September 2015

IQEye Cameras Firmware

General Description

Day/night threshold values

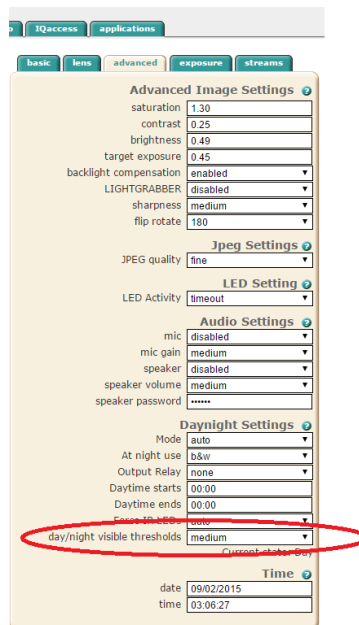
Added to the advanced image settings tab is the option to select the light level at which the camera will switch from day mode to night mode and back. This option offers three levels, low-medium-high, where **low** means the camera will enter night mode later (lower light) and enter sooner. The default is medium.

IR control

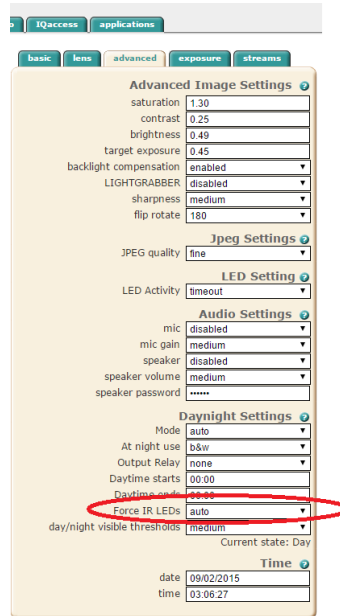
Added the ability to set the IR illuminators to always on and always off (in addition to auto).

Day/night motion sensitivity

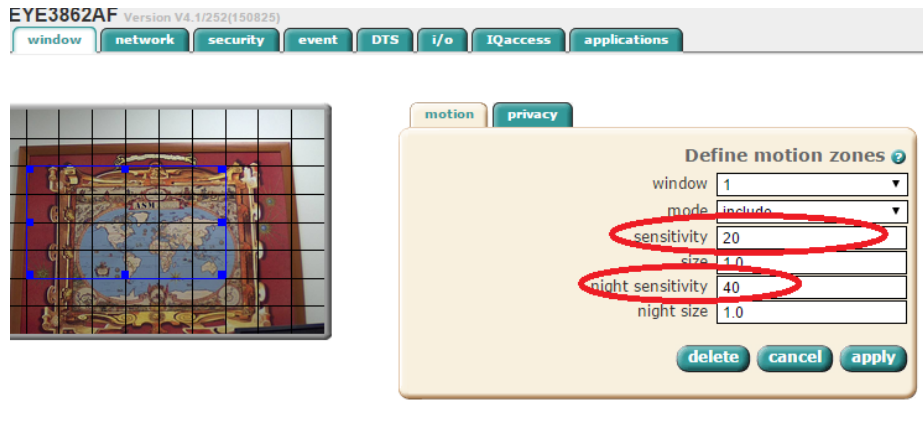
Separated motion sensitivity to allow setting a different level for day and night times.
